SECTION 00911 - ADDENDUM 1

- A. Project Name: South Main Corridor Improvement Project (Phase II)
- B. Engineer: SK Design Group, Inc.
- C. Engineer's Project Number: 16-108.
- D. Date of Addendum: 2024-05-03

City of Maryville, Missouri
 South Main Improvement Phase II & Pedestrian Enhancements
 Project #'s: STP-4301104 and TAP-4301106
 Pre-Bid Meeting Notes – April 30, 2024, at 1:00 p.m.

C30.04

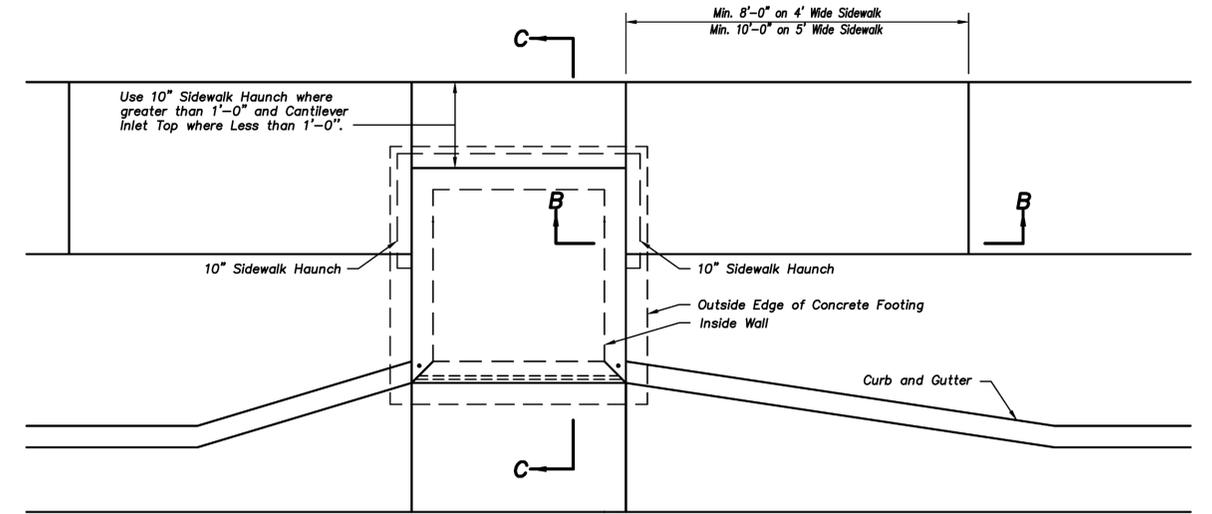
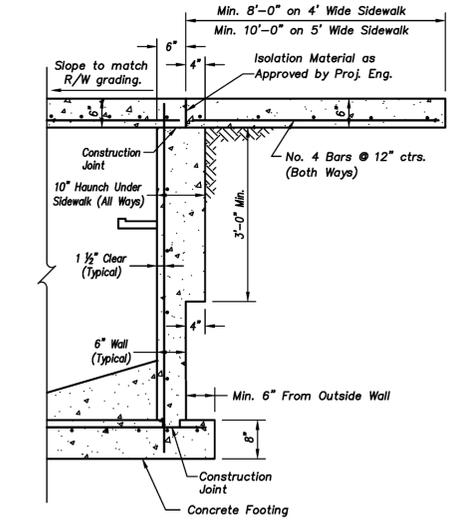
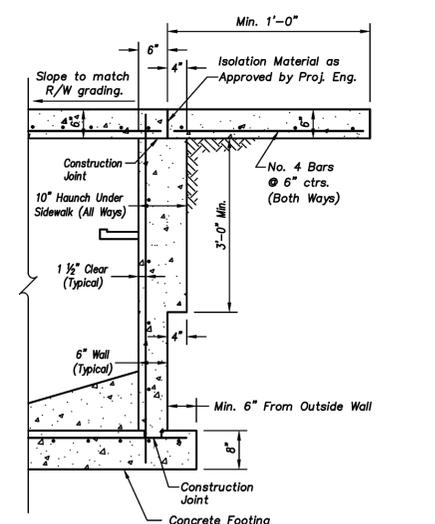
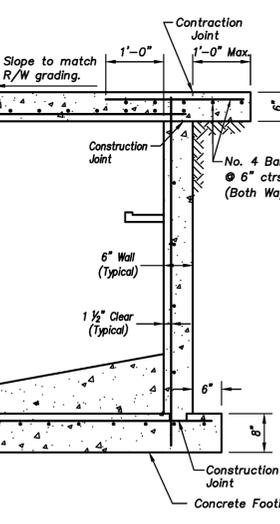
- A. Question: On Sheet C20.01 it indicates that precast inlet tops are allowed on the project. However, on sheet C30.04 Note 1 it indicates that if the structures are precast that the tops must be cast in place. Can you clarify if precast tops are allowed?

Response: Notes on Sheets C30.03 and C30.04 are revised to match that on Sheet C20.01. Precast inlet tops are acceptable as long as the top slopes with the pavement grades.

- A. Sheet C20.01: Revised to remove nighttime work language.
- B. Sheet C30.03: Revised to indicate precast inlet top is acceptable as long as the top slopes with the pavement grades.
- C. Sheet C30.04: Revised to indicate precast inlet top is acceptable as long as the top slopes with the pavement grades.
- D. Sheet C33.15: Revised to remove nighttime work language.
- E. Sheet C33.16: Revised to remove nighttime work language.
- F. Sheet C33.17: Revised to remove nighttime work language.
- G. Sheet C33.18: Revised to remove nighttime work language.

1 MAIN STREET ROADWAY LIGHTING PLAN PARTIAL

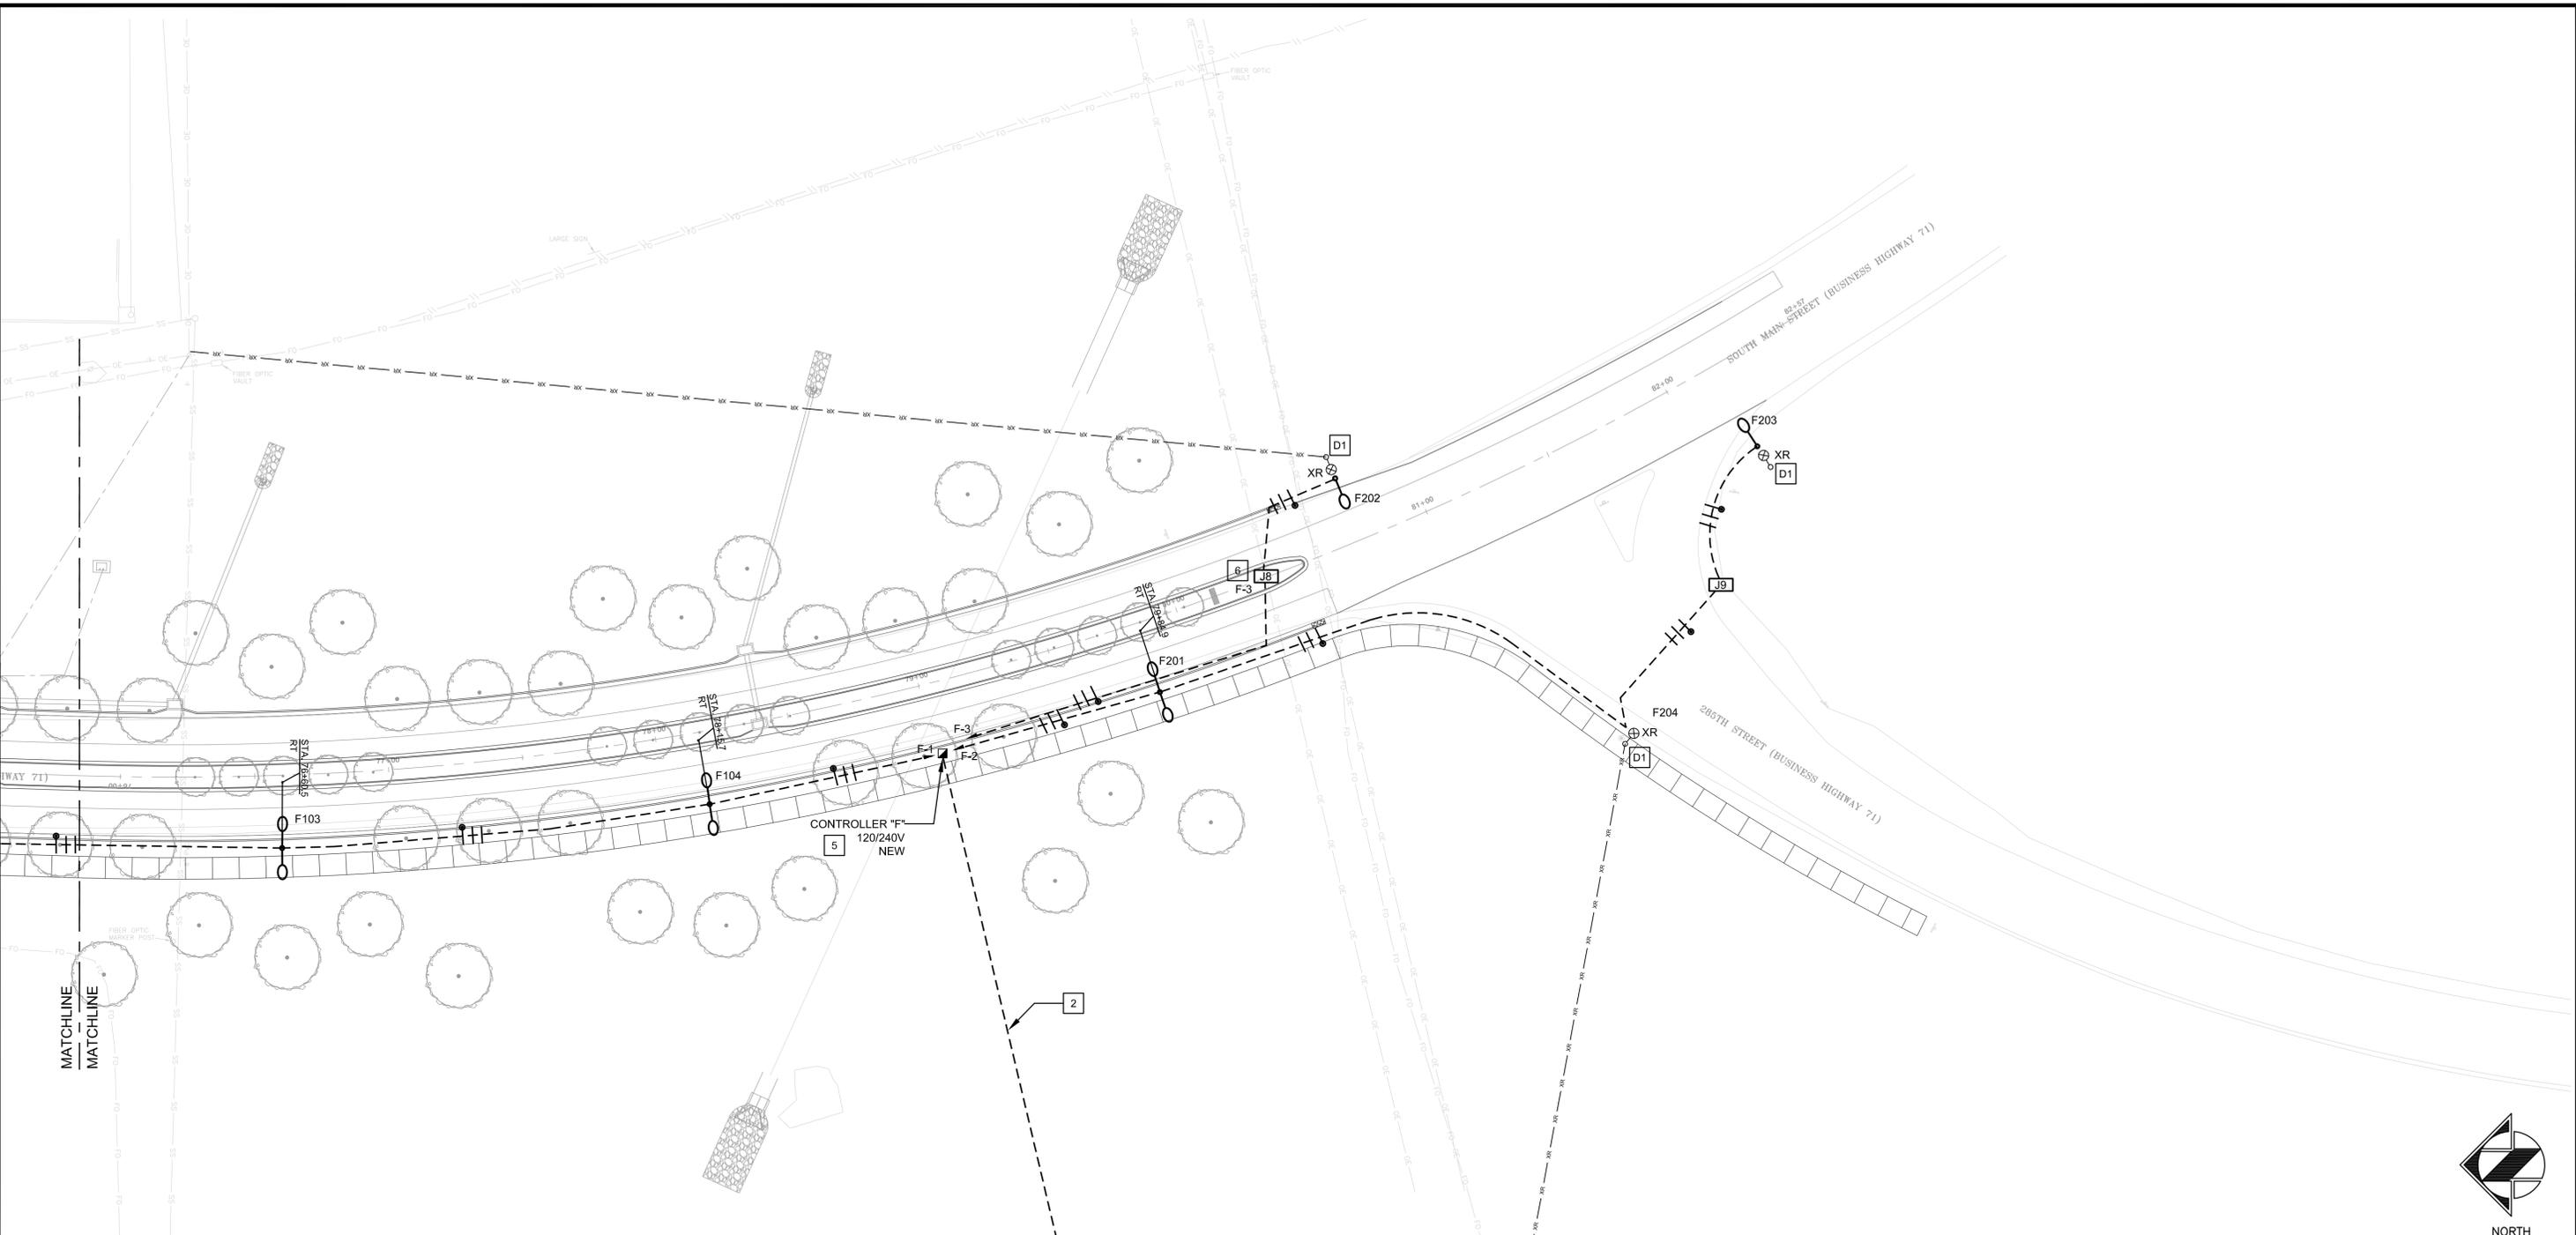
Response: SE002 has been revised. See attached.
- D. Question: On Sheet SE204 the plans identify Controller F to be a 2CKT controller, however on sheet SE002 the table calls out Controller F to be a 4CKT. Please clarify which size of controller is required.

- E. Question: There seems to be a discrepancy with the routing of conduit On sheet SE 204 compared to what is called out on SE002. Sheet SE002 indicates a conduit from F201 to J8. Sheet SE204 does not show this and 3 conduits in a screw in base will be difficult. Please clarify routing.

Response: Keynote 5 on Sheet SE204 has been revised to reflect Controller F to be a 4 CKT controller. SE303 and SE002 remain correct indicating a 4CKT controller. See attached.

Response: Routing is shown correctly on SE204. SE002 has been revised to reflect plan sheet. See attached.

- 1 NEW 100 AMP, 240/120 V, 1PH, 4 CKT LIGHTING CONTROLLER PER EQUIPMENT LIST. FIELD LOCATE FOR APPROVAL BY OWNER'S REPRESENTATIVE PRIOR TO INSTALLATION.
- 2 (1) 3" EMPTY CONDUIT WITH PULLSTRING TO UTILITY POINT OF CONNECTION (POC). ALL ELECTRICAL EQUIPMENT MUST BE IN THE CITY'S RIGHT OF WAY. THE TRANSFORMER AND SECONDARY DROP MUST BE IN A UTILITY EASEMENT. COORDINATE EXACT LOCATION OF POC AND LIGHTING CONTROLLER WITH EVERY PRIOR TO START OF PROJECT. THE CONTRACTOR IS RESPONSIBLE FOR COORDINATING WITH EVERY ALL UTILITY UPGRADES TO PROVIDE THE SERVICES INDICATED. RE: DETAILS FOR ADDITIONAL UTILITY CONNECTION INFORMATION.
